TECHNICAL RESPONSE TO HCC HIGHWAYS COMMENTS

Ridge and Partners have been commissioned to respond to the Road Safety Audit undertaken by Fenley (March 2026) as part of the S278 Technical Approval Process.

Road Safety Audit Report

Proposed Continuation of Coldharbour Farm Road Emsworth

TITLE:
S278 TRACKING
CAR PARKING
SHEET 1

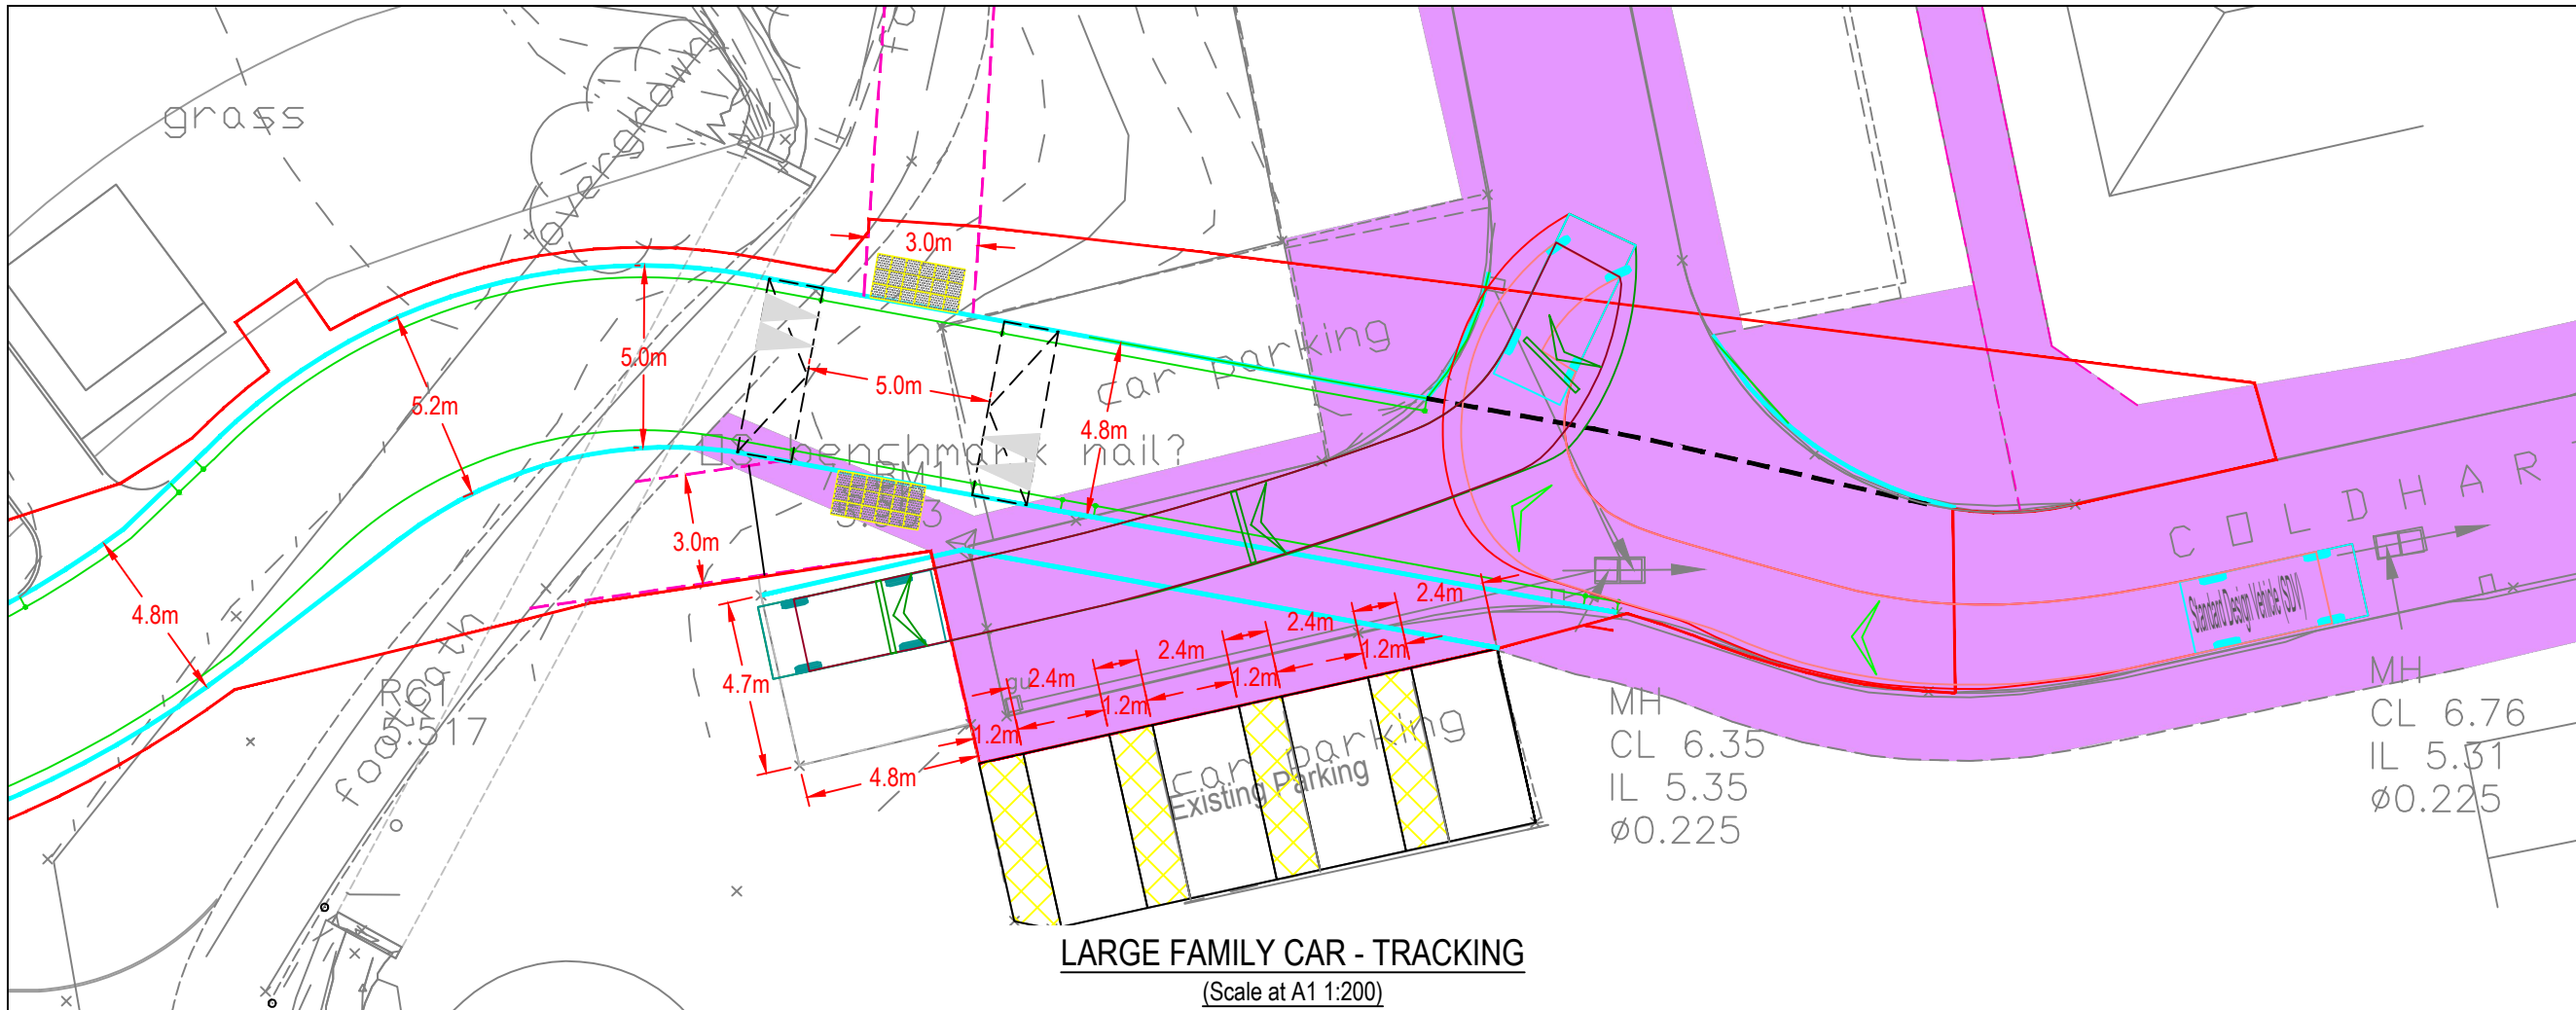
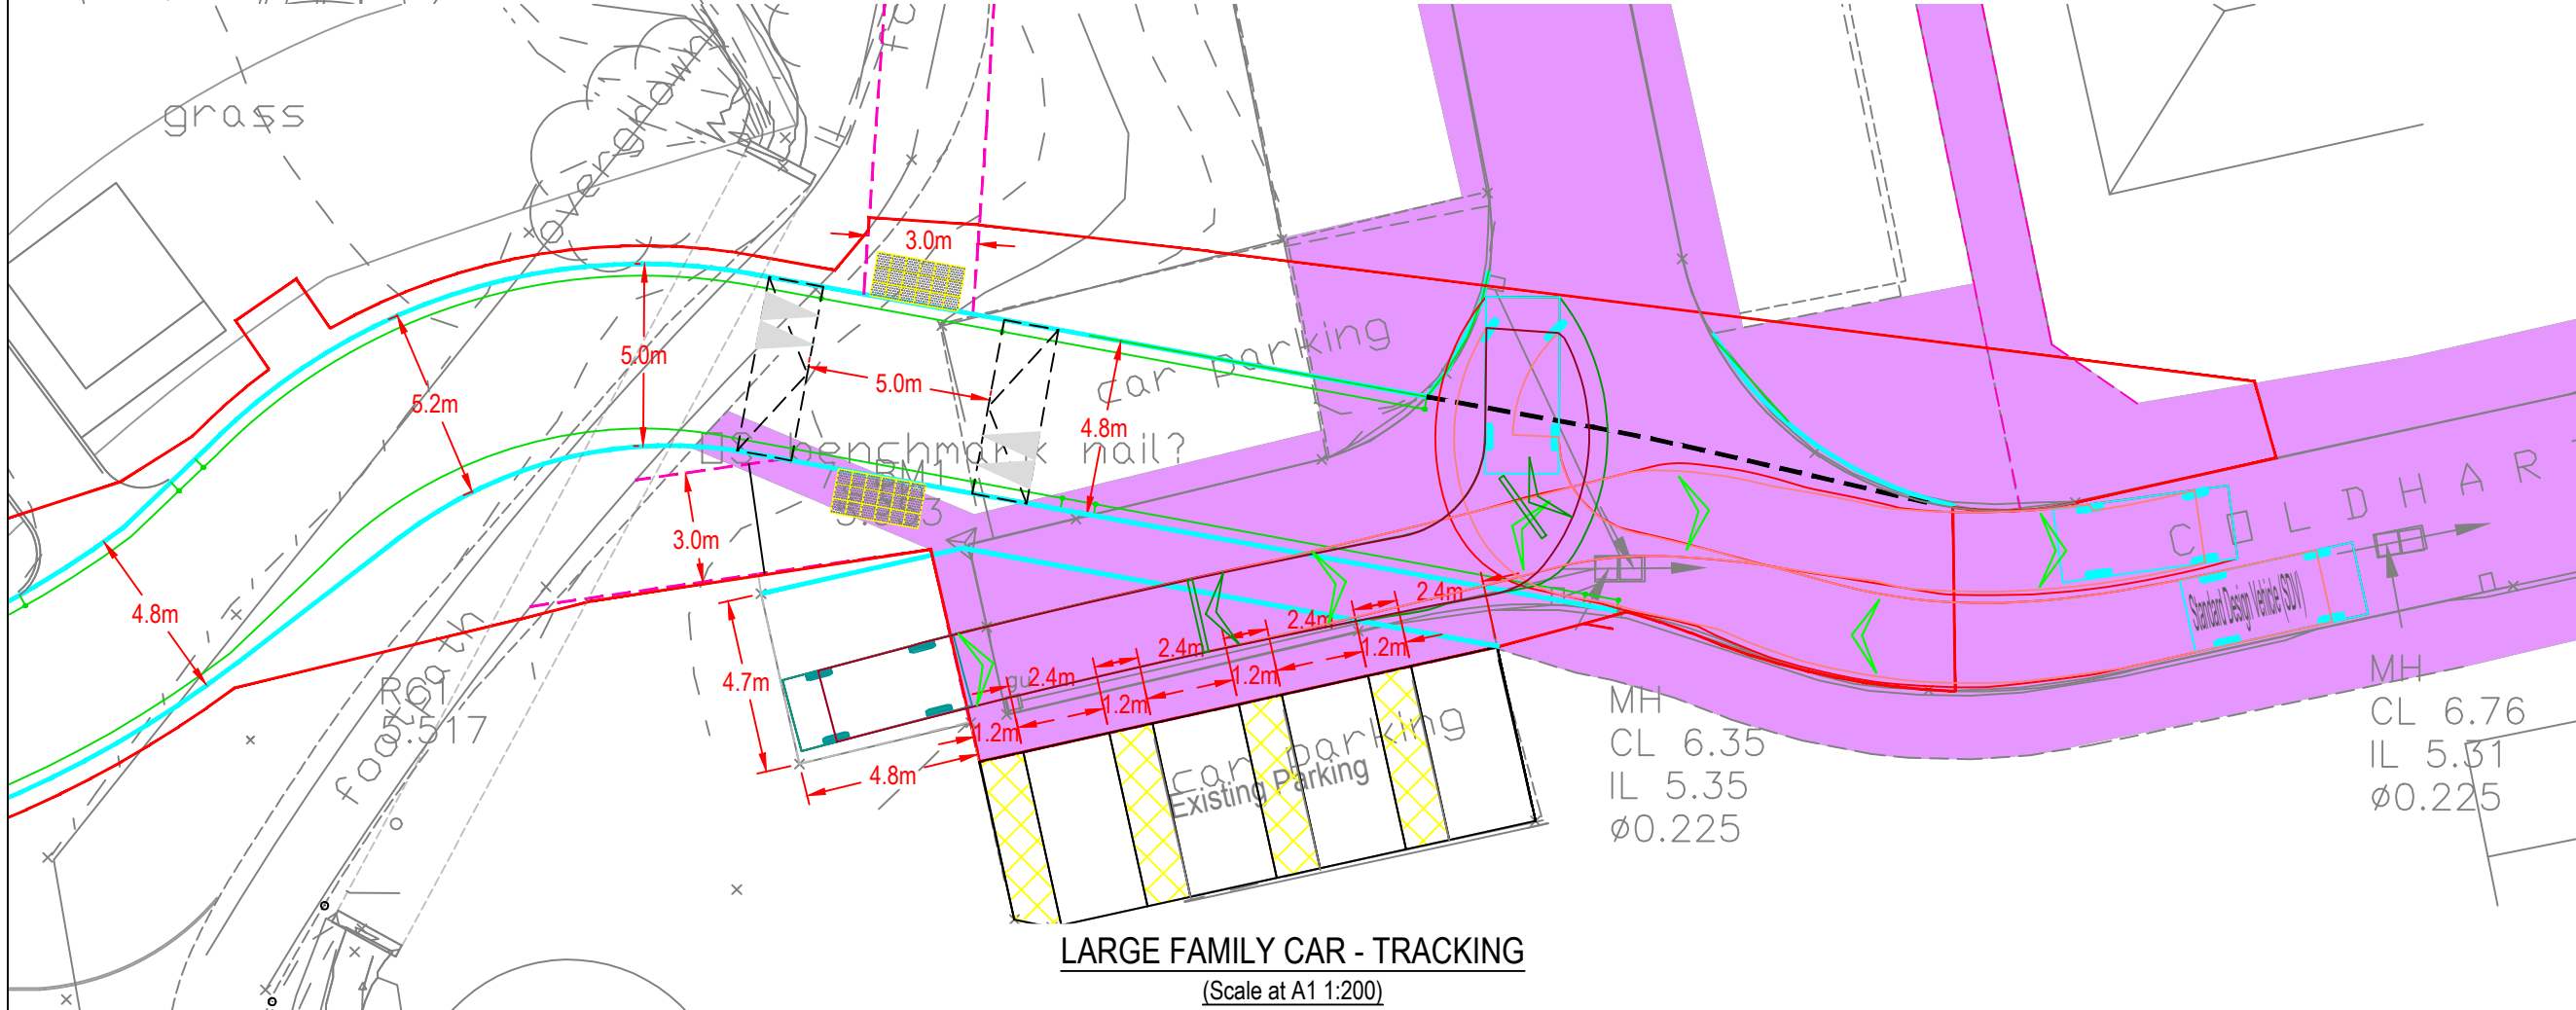
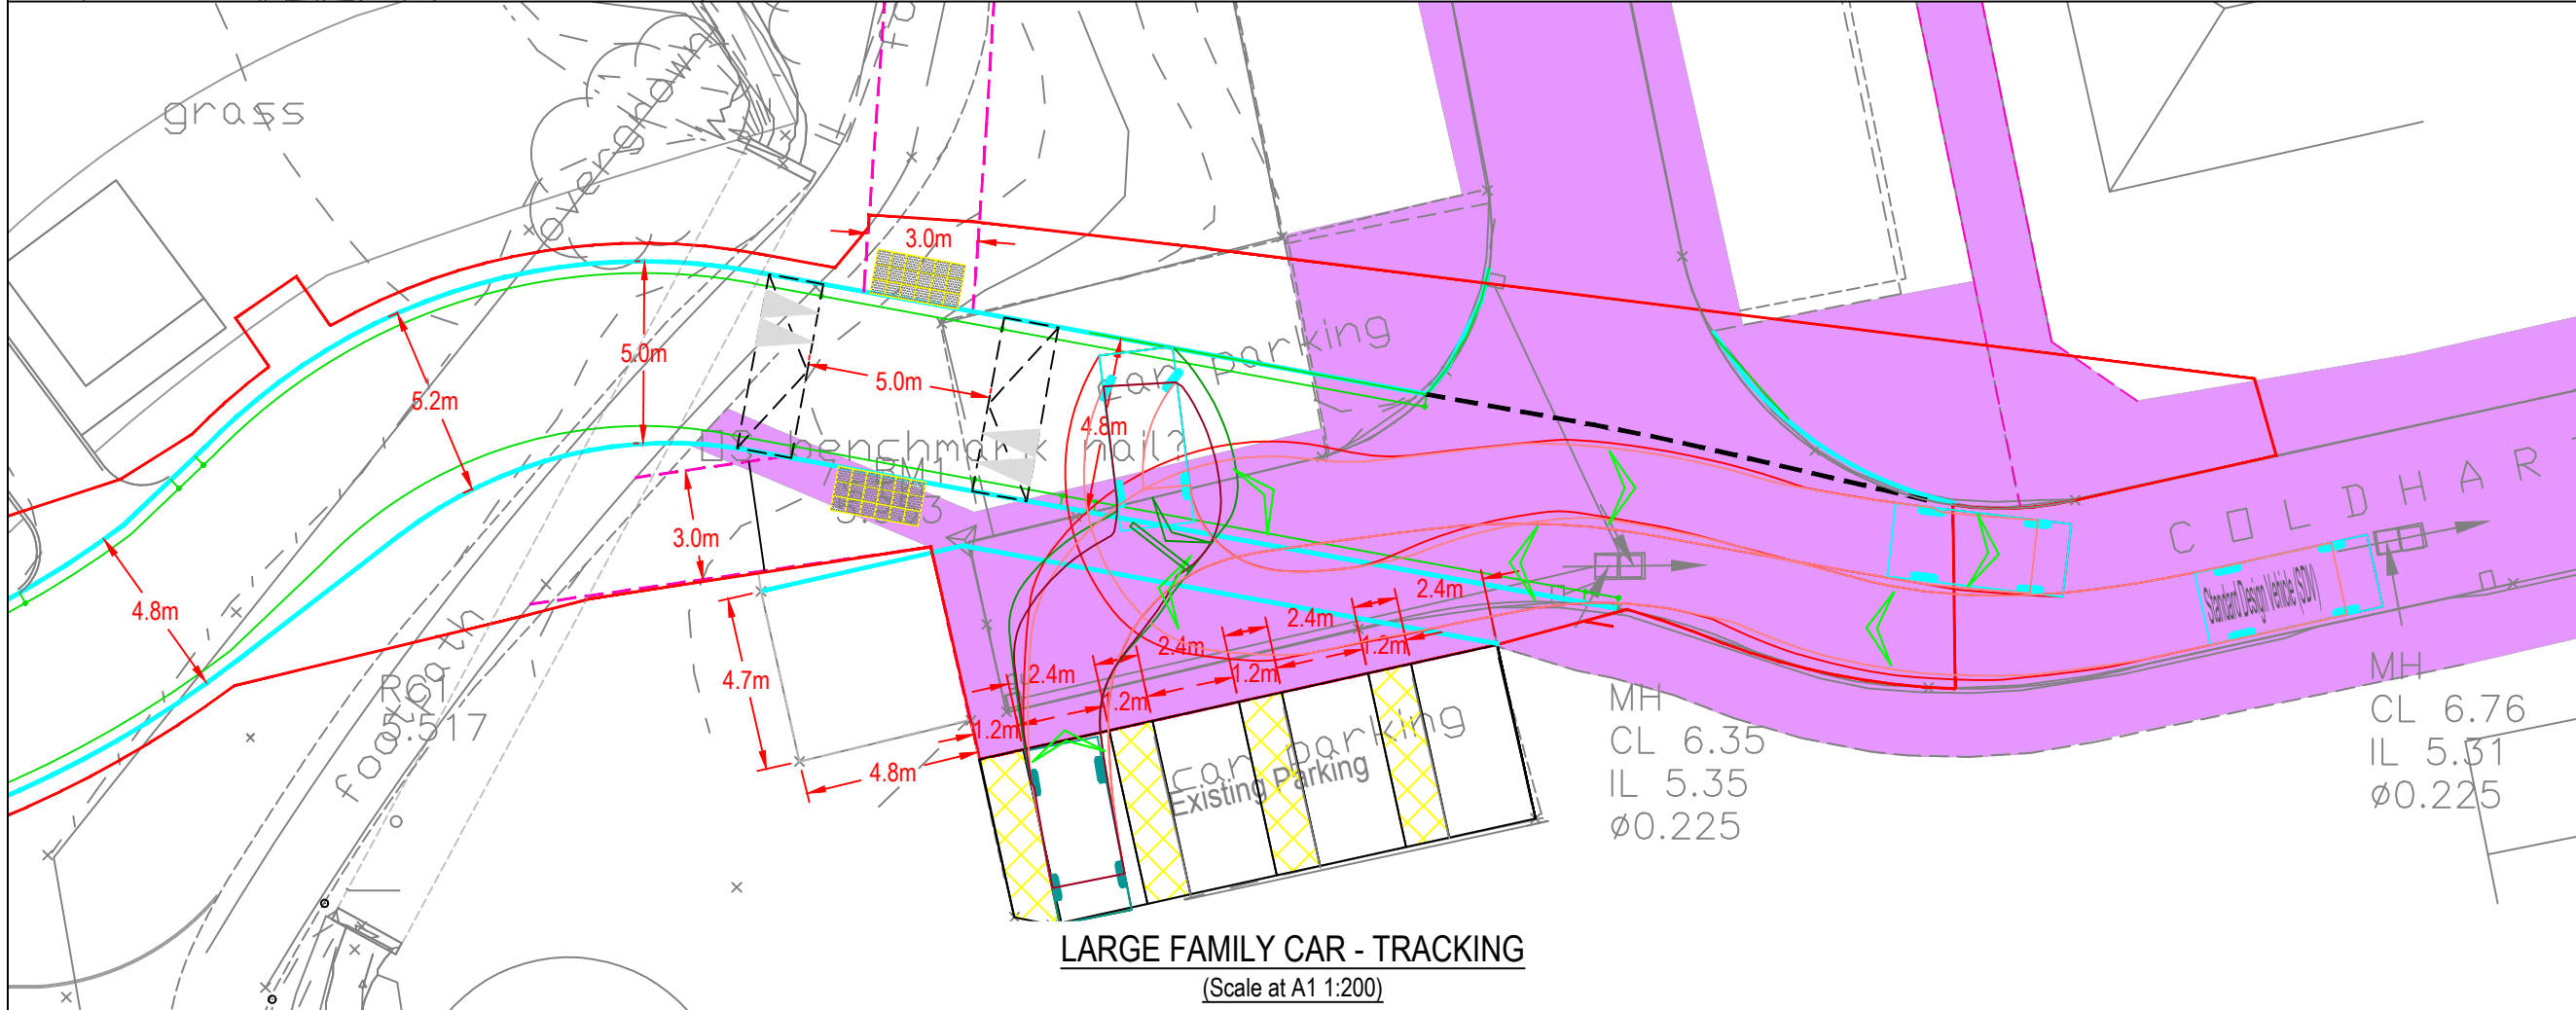
B2.2 Vehicles may not be able to access the existing parking bays. It is recommended that the bays are accessible.

The existing parking bays are proposed to be relined as shown on Drawing 23339-JUBB-XX-XX-DR-X-000100 REV C13 and the tracking is shown on Drawing 23339-JUBB-XX-XX-DR-X-001203 REV C1.
